### FAULTY DUCT

Dishwasher of width 45cm.

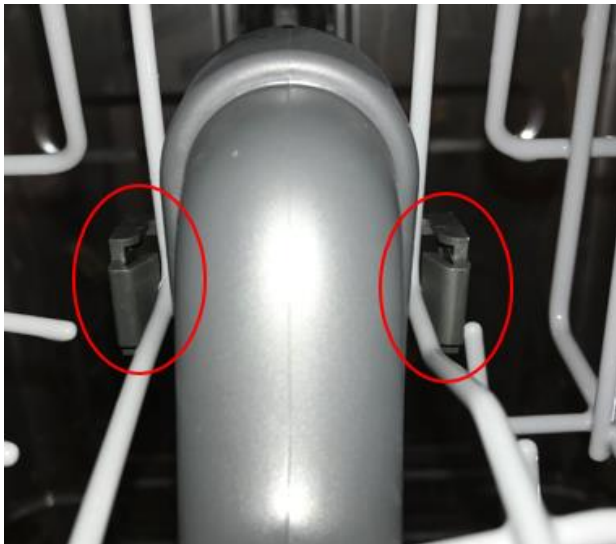
There is a possibility of an issue being present in an appliance, where duct won't be kept in the correct place on upper basket.

Replacement of the duct with the one from the TDS database.

Examples of KO (improperly holding onto the basket) component and OK component below:

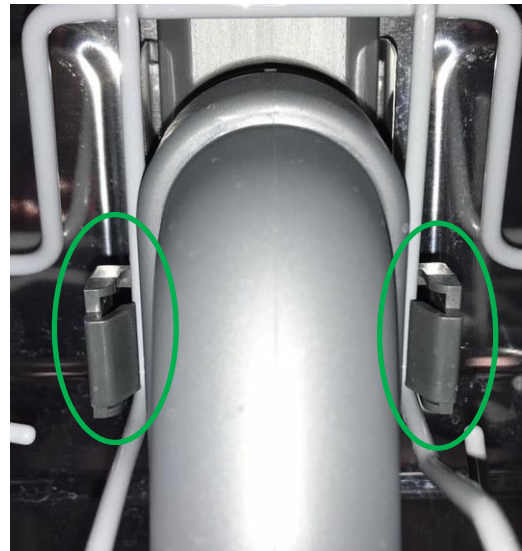
1. Hooks are improperly hooked to the basket

2. Properly mounted component
